OCONEE NUCLEAR STATION, UNIT NO. 1

AMENDMENT TO FACILITY OPERATING LICENSE

Amendment No. 66
License No. DPR-38

ATTACHMENTS TO LICENSE AMENDMENTS

OCONEE NUCLEAR STATION
Figure 2.1-2B

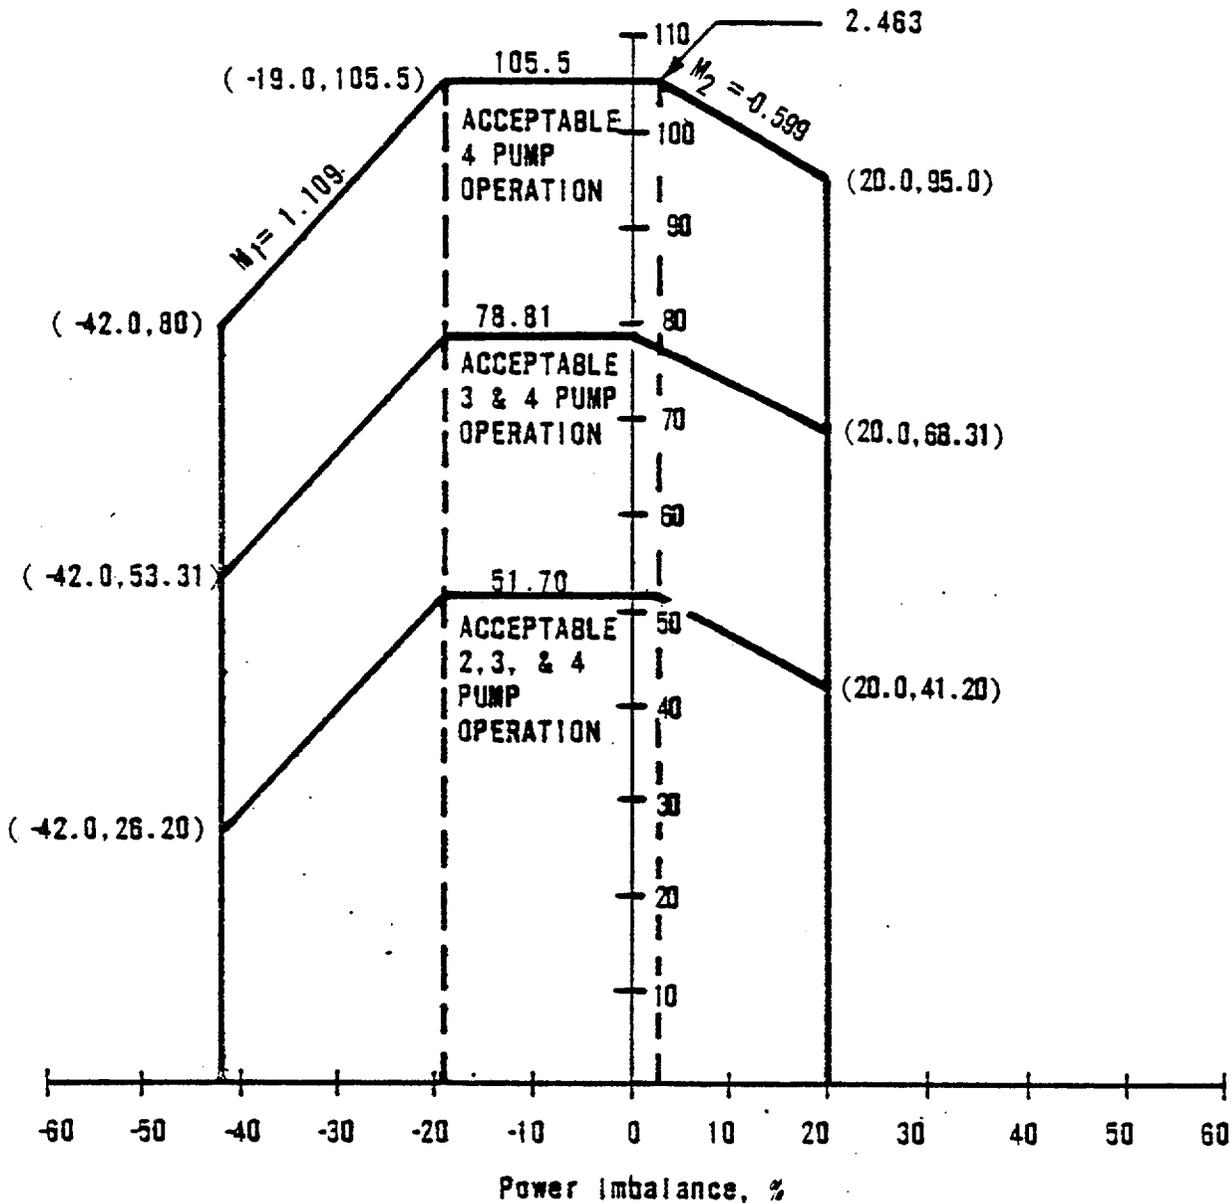
The curves of Figure 2.1-2B are based on the more restrictive of two thermal limits and include the effects of potential fuel densification and fuel rod bowing:

The specified flow rates for Curves 1, 2, and 3 of Figure 2.1-2B correspond to the expected minimum flow rates with four pumps, three pumps, and one pump in each loop, respectively.

1. Modification to Core Protection Safety Limits
(Figure 2.1-2B)*
2. Modification to Protective System Maximum Allowable Setpoints
(Figure 2.3-2B)
3. Modifications to Rod Position Limits
(Figures 3.5.2-1B1, 1B2, 2B1, and 2B2)
4. Modifications to Operational Power Imbalance Envelope
(Figures 3.5.2-3B1 and 3B2)
5. Modifications to APSR Position Limits
(Figures 3.5.2-4B1 and 4B2)
6. Reduction in $F_{\Delta H}$ from 1.78 to 1.71
7. Increase in the allowed steady state quadrant tilt to 5%
and in the linear heat rate peaking increase associated
with positive tilt to 7.50%.

OCONEE NUCLEAR STATION
 Figure 3.5.2-3B1

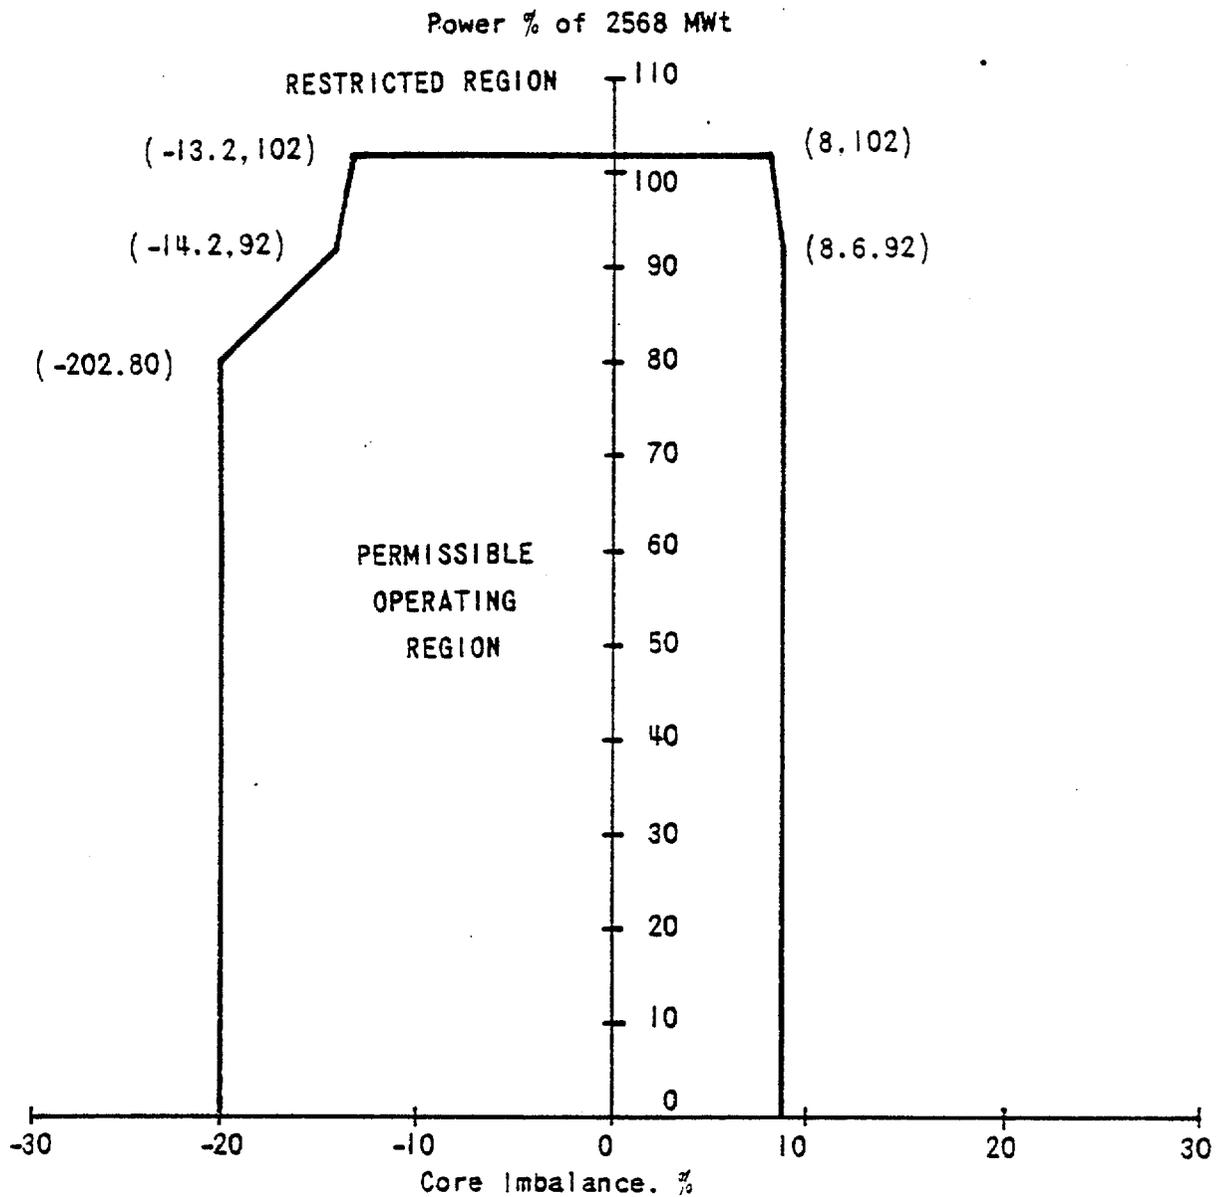
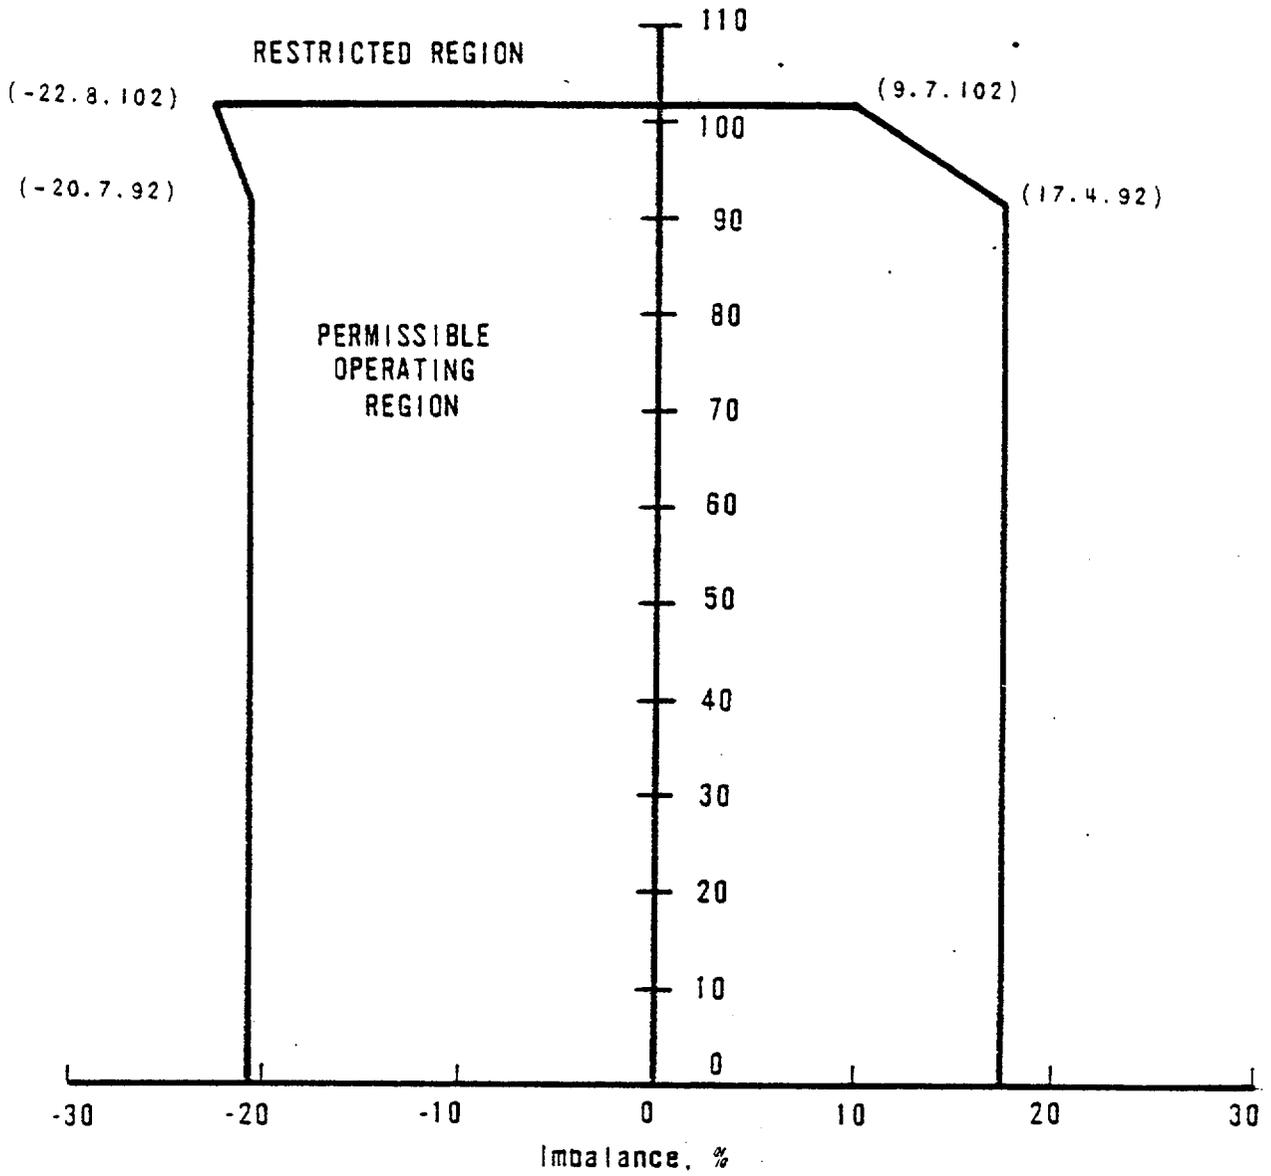
The power-imbalance envelope defined in Figures 3.5.2-3A1 and -3A2, 3.5.2-3B1, -3B2 and -3B3, 3.5.2-3C1, -3C2 and -3C3 is based on LOCA analyses which have defined the maximum linear heat rate (see Figure 3.5.2-5) such that the maximum clad temperature will not exceed the Final Acceptance Criteria. Corrective measures will be taken immediately should the indicated quadrant tilt, rod position, or imbalance be outside their specified boundary. Operation in a situation that would cause the Final Acceptance Criteria to be approached should a LOCA occur is highly improbable because all of the power distribution parameters (quadrant tilt, rod position, and imbalance) must be at their limits while simultaneously all other engineering and uncertainty factors are also at their limits.** Conservatism is introduced by application of:

Figure 3.5.2-4B1

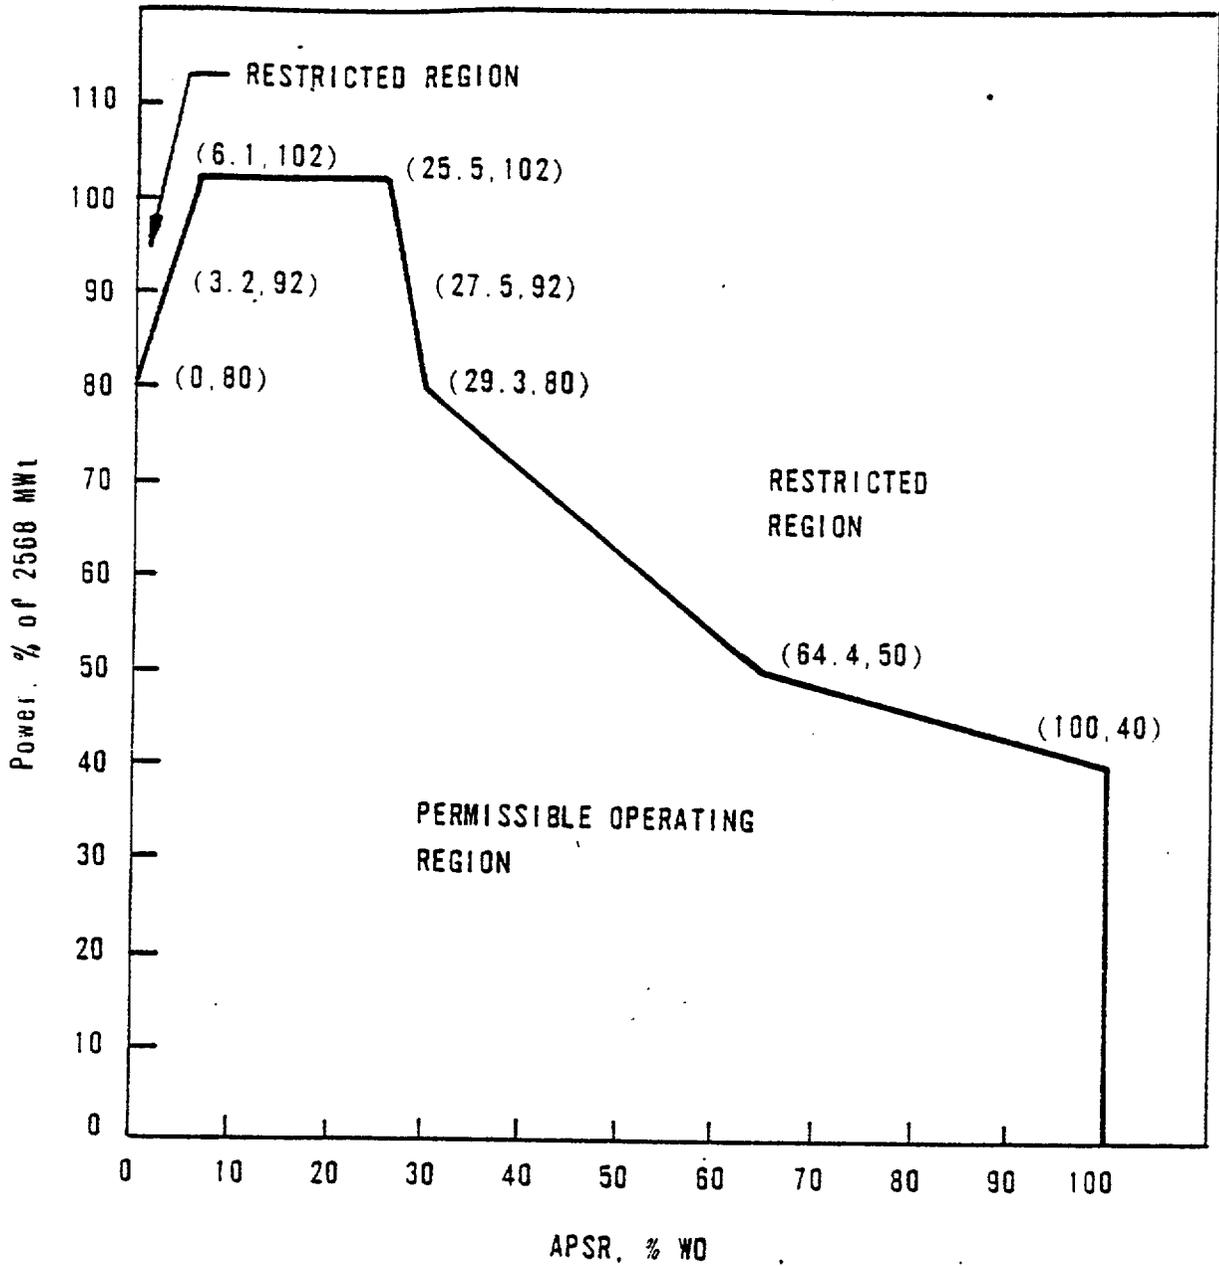
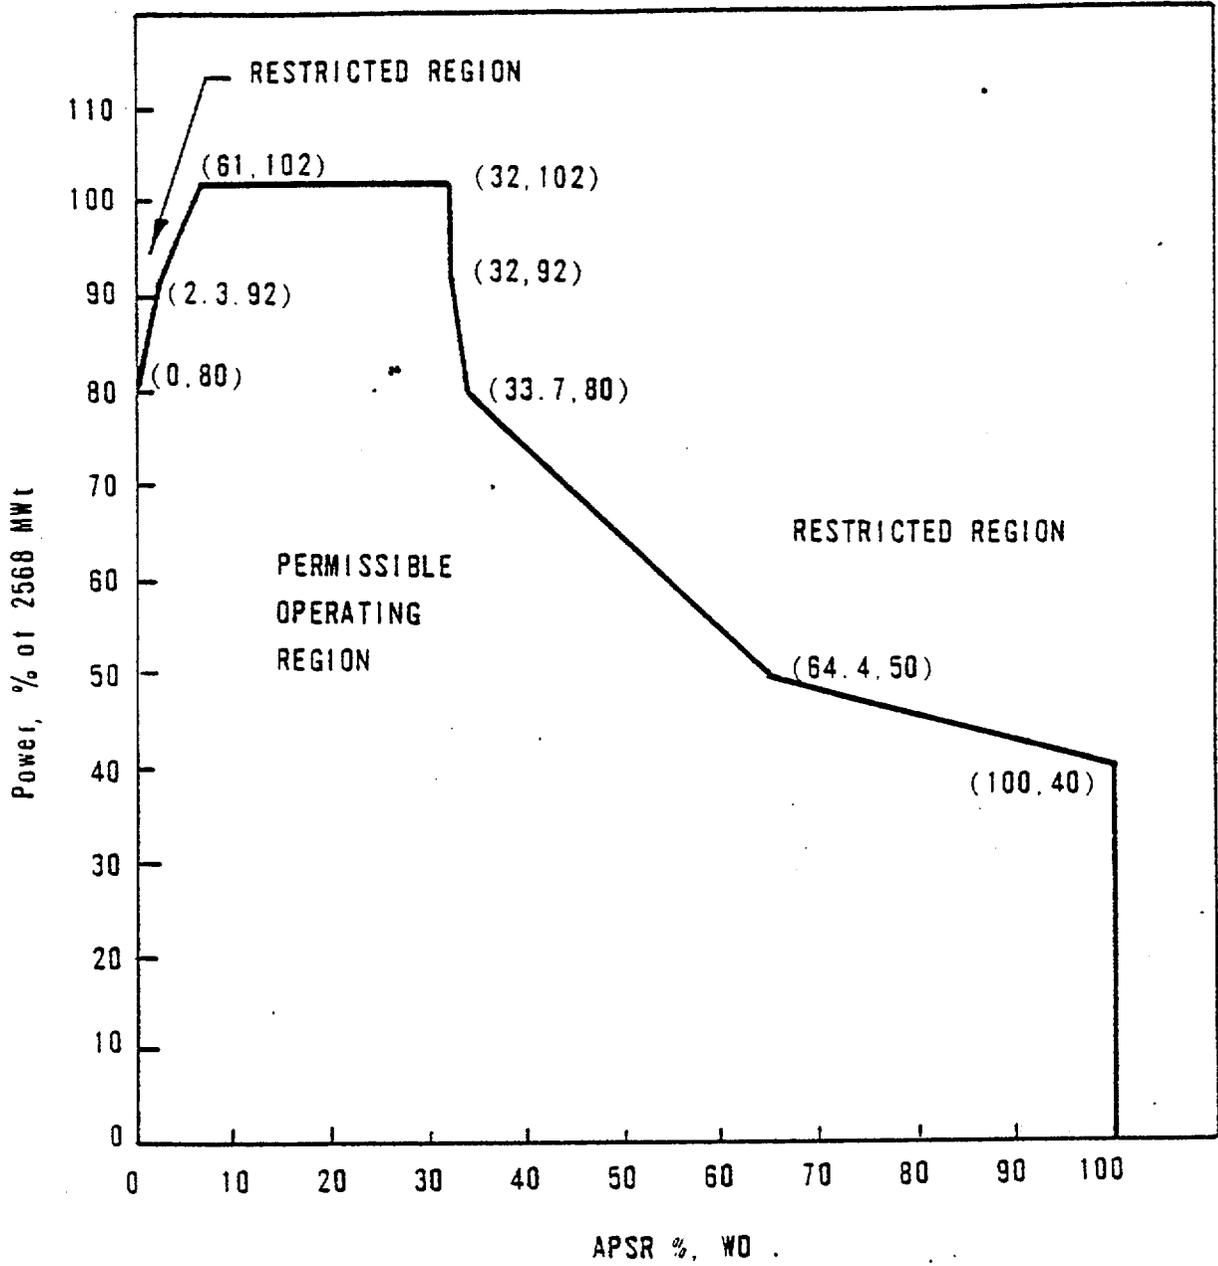
- c. Position limits are specified for regulating and axial power shaping control rods. Except for physics tests or exercising control rods, the regulating control rod insertion/withdrawal limits are specified on figures 3.5.2-1A1 and 3.5.2-1A2 (Unit 1); 3.5.2-1B1, 3.5.2-1B2 and 3.5.2-1B3 (Unit 2); 3.5.2-1C1, 3.5.2-1C2 and 3.5.2-1C3 (Unit 3) for four pump operation, and on figures 3.5.2-2A1 and 3.5.2-2A2 (Unit 1); 3.5.2-2B1, 3.5.2-2B2 and 3.5.2-2B3 (Unit 2); 3.5.2-2C1, 3.5.2-2C2 and 3.5.2-2C3 (Unit 3) for two or three pump operation. Also, excepting physics tests or exercising control rods, the axial power shaping control rod insertion/withdrawal limits are specified on figures 3.5.2-4A1, and 3.5.2-4A2 (Unit 1); 3.5.2-4B1, 3.5.2-4B2, and 3.5.2-4B3 (Unit 2); 3.5.2-4C1, 3.5.2-4C2, and 3.5.2-4C3 (Unit 3).
